BASE REALIGNMENT AND CLOSURE FOCUSED FEASIBILITY STUDY AREA 2 HERNDON  
ANNEX WITH TRANSMITTAL LETTER NTC ORLANDO FL  
11/15/1999  
HARDING LAWSON ASSOCIATES

**Subject: Final BRAC Focused Feasibility Study  
Study Area 2, Herndon Annex  
NTC Orlando, Florida  
Contract No. N62467-89-D-0317/107**

**RESPONSE TO USEPA REGION IV COMMENTS  
DRAFT NATURAL ATTENUATION MONITORING WORK PLAN  
STUDY AREA 2 HERNDON ANNEX, NTC ORLANDO**

### Historical Benzene Data

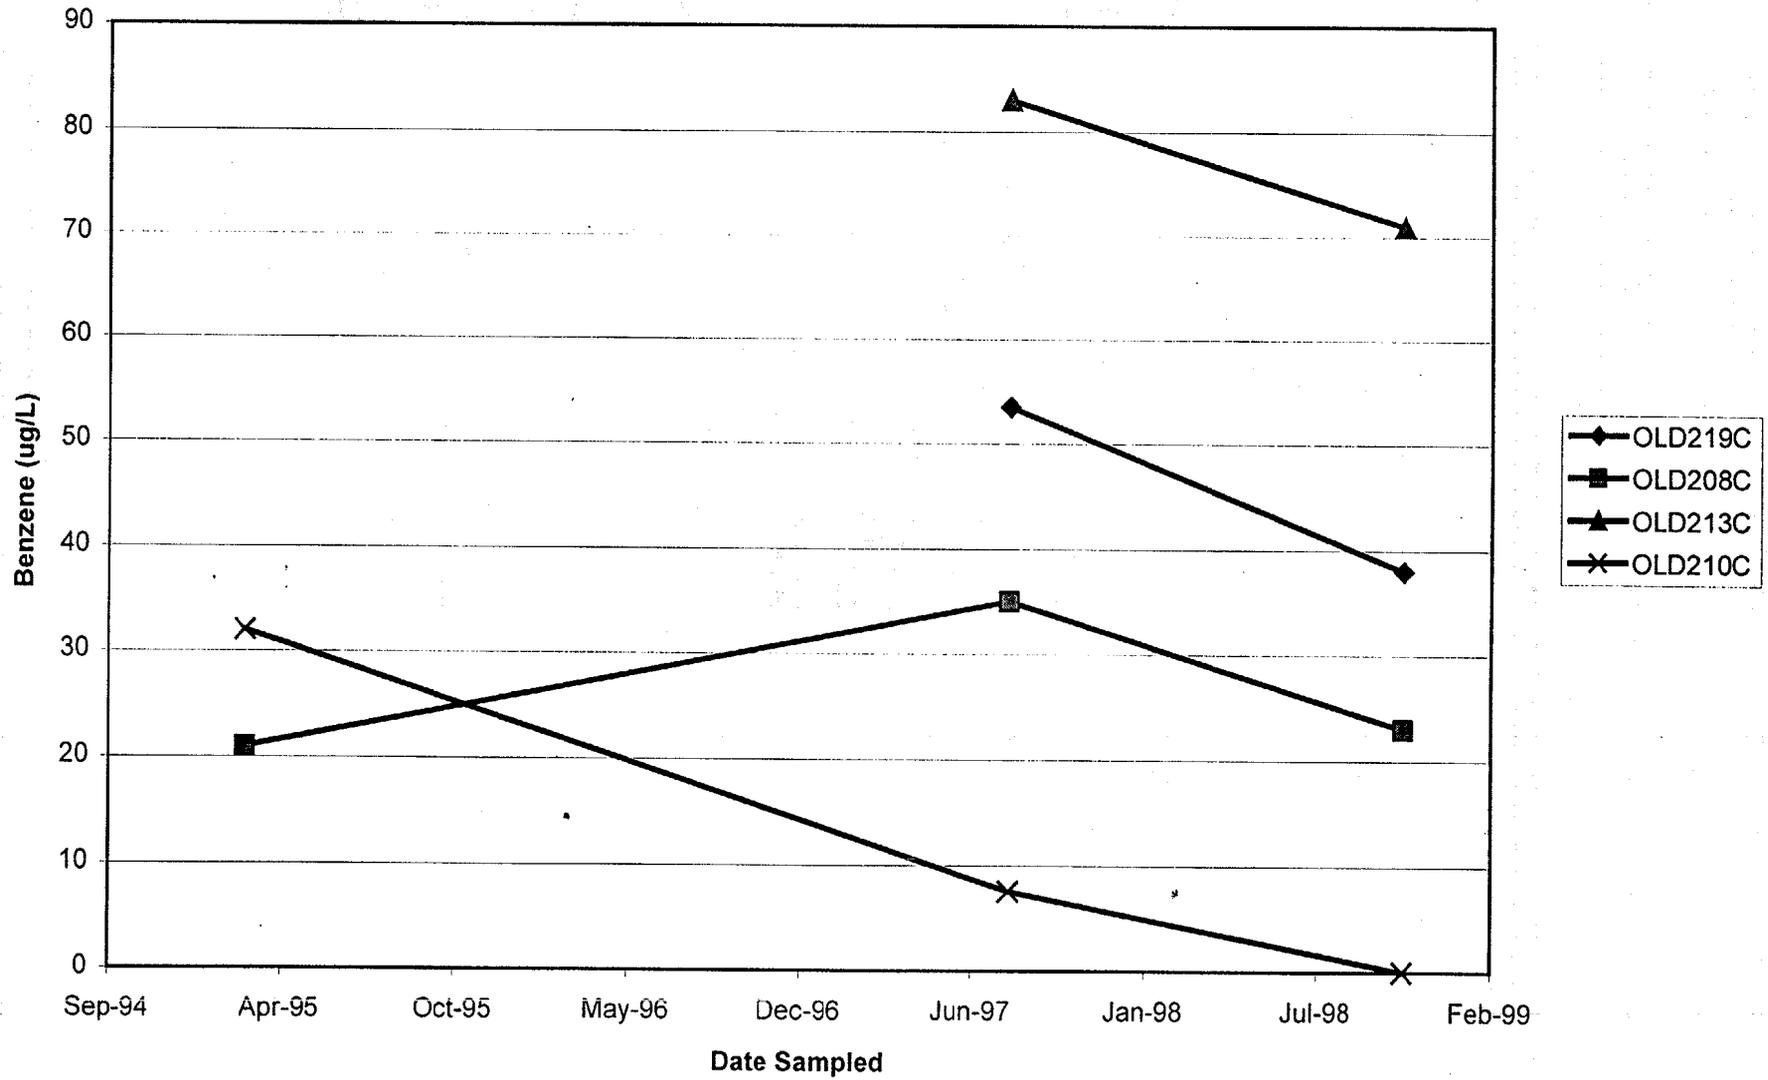
1. **Data presented in the first figure of Appendix A contradicts the statement at the bottom of page 5 that: "In no instance was there an increase in the concentration of benzene." The first figure in Appendix A shows that benzene concentrations in monitoring wells OLD219C and OLD208C increased between the March, 1995 and August-November, 1997 sample events. Further, the benzene concentration in well OLD208C in December, 1998 remained higher than the concentration observed in March, 1995. In addition, Table A-1 shows that two wells (OLD220B and OLD221C) with benzene concentrations 9-10 times the MCL for benzene in December, 1998, were not sampled in previous events, so this report contains no data to support the statement that benzene concentrations are not increasing. The last sentence on page 5 should be deleted.**

2. **The March 1995 concentration for benzene in well OLD219C is plotted on the first figure in Appendix A, but is shown as "n/a" on Table A-1. Either the table or figure should be corrected.**

HLA concurs that this statement is confusing and will strike it from the document.

There was an error in the graph presented in Appendix 1, HLA will correct the graph.
